UNITED STATES PATENT AND TRADEMARK OFFICE

10/699,604

KIM, DAVID S

DETAILED ACTION**Drawings**

**FIG. 5**

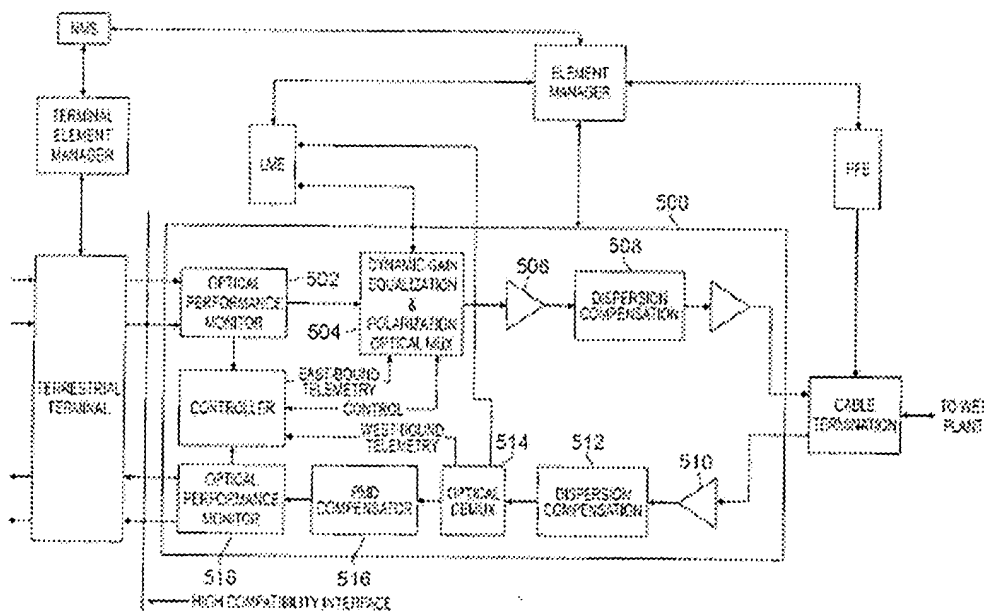
In the original disclosure, the specification states that Fig. 4 shows an embodiment of the optical interface device shown in U.S. Application Serial No. 10/621,028. Note the corresponding embodiment in Fig. 5 from U.S. Application Serial No. 10/621,028.

Fig. 4 from the instant application is very similar to Fig. 5 from U.S. Application Serial No. 10/621,028. Clearly, Fig. 5 from U.S. Application Serial No. 10/621,028 corresponds Applicant's Fig. 4 of the instant application. Again, clearly, Fig. 5 from U.S. Application Serial No. 10/621,028 does not show Raman pump source 507 and the connection from 507 to the line between 505 and 522. Accordingly, Applicant's amendment to Fig. 4 is not supported, and Applicant's amended Fig. 4 is disapproved.

FIG. 2

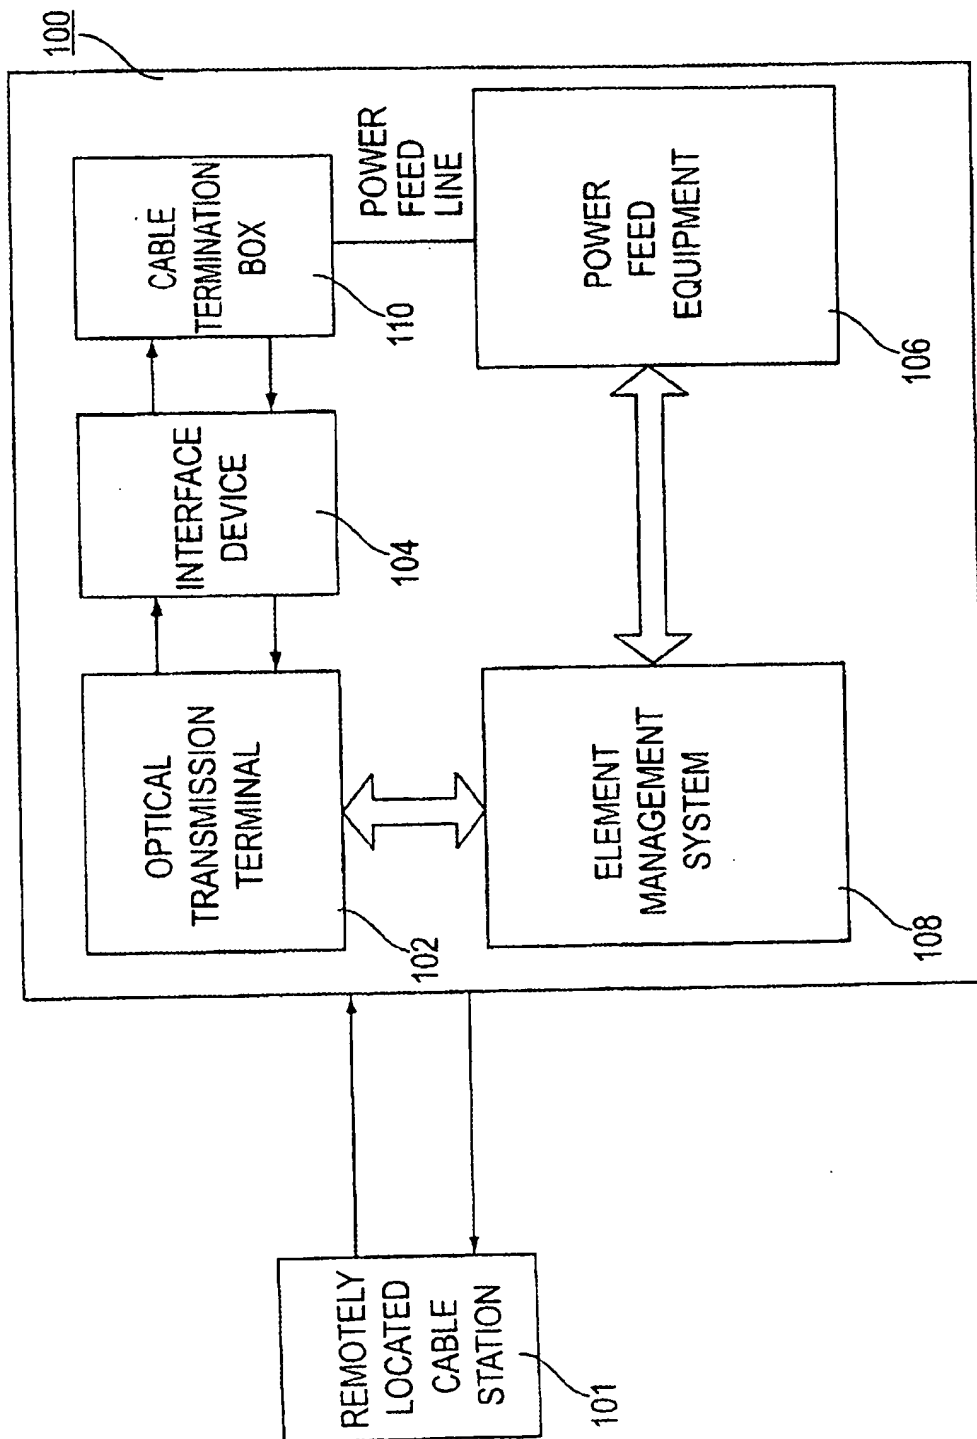
- The replacement drawing for Fig. 2 is disapproved. Although the amended Fig. 2 itself is acceptable, this drawing is objected to as failing to comply with 37 CFR 1.84(p)(5) because it includes the following reference character not mentioned in the description: 101.
- The replacement drawing for Fig. 4 is disapproved. Applicant amended Fig. 4 of the instant application to include Raman pump source 507 and the connection from 507 to the line between 505 and 522. However, the original disclosure does not support Applicant's amendment.

2. Corrected drawing sheets in compliance with 37 CFR 1.121(d) are required in reply to the Office action to avoid abandonment of the application. Any amended replacement drawing sheet should include all of the figures appearing on the immediate prior version of the sheet, even if only one figure is being amended. The figure or figure number of an amended drawing should not be labeled as "amended." If a drawing figure is to be canceled, the appropriate figure must be removed from the replacement sheet, and where necessary, the remaining figures must be renumbered and appropriate changes made to the brief description of the several views of the drawings for consistency. Additional replacement sheets may be necessary to show the renumbering of the remaining figures. Each drawing sheet submitted after the filing date of an application must be labeled in the top margin as either "Replacement Sheet" or "New Sheet" pursuant to 37 CFR 1.121(d). If the changes are not accepted by the examiner, the applicant will be

FIG. 4

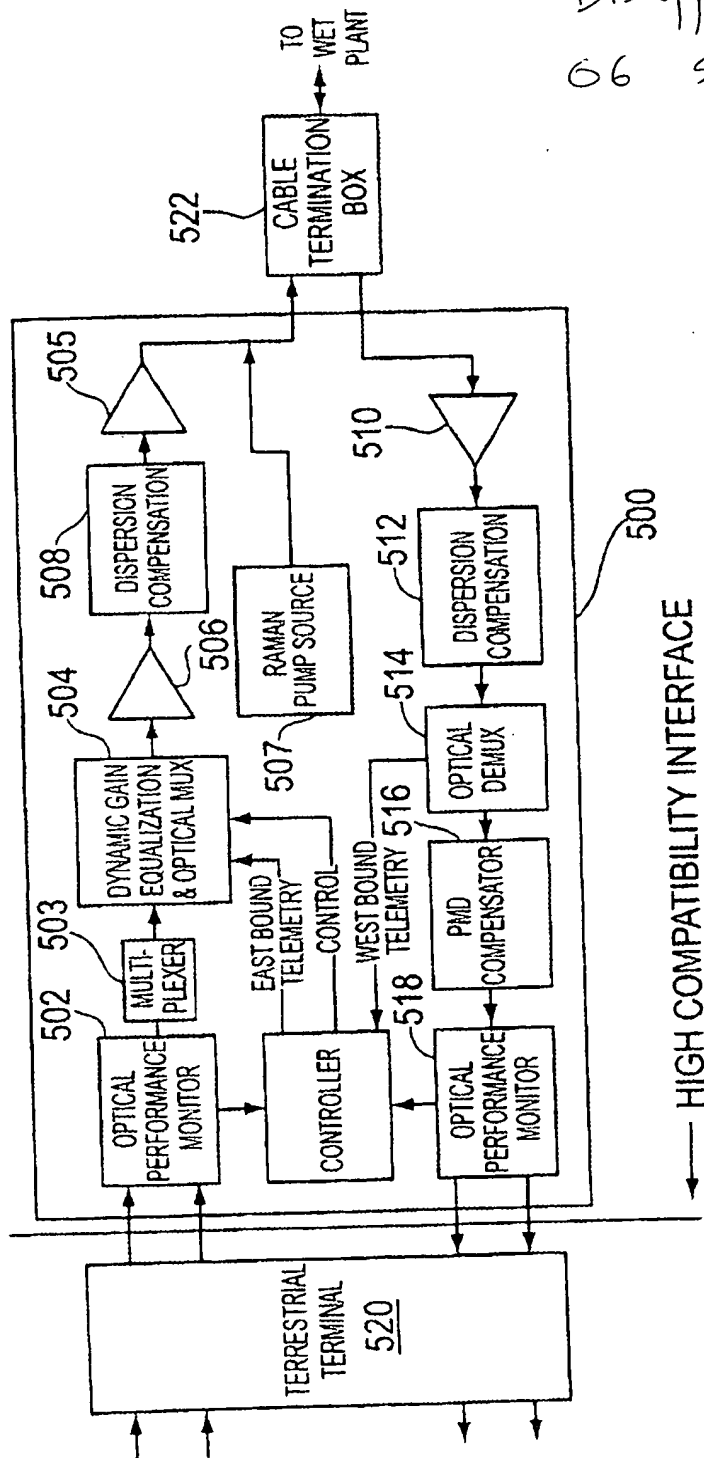
Moreover, even if one could reasonably argue that the embodiment of Fig. 4 may support the inclusion of Raman pump source 507, the connection from 507 to the line between 505 and 522 is not supported by the original disclosure.

- Although original claims 10, 20, 32, and 44 do disclose "means for supplying pump power to impart Raman amplification to the optical signals", drawing such means in the embodiment of Fig. 4 is not supported. On the other hand, these means may be supported in another drawing (not Fig. 4) of another embodiment of the interface device. Still, as these means are not provided in any approved drawing, the drawings are objected to under 37 CFR 1.83(a). The drawings must show every feature of the invention specified in the claims. Therefore, the "means for supplying pump power to impart Raman amplification to the optical signals" must be shown or the feature canceled from the claims 10, 20, 32, and 44. No new matter should be entered.
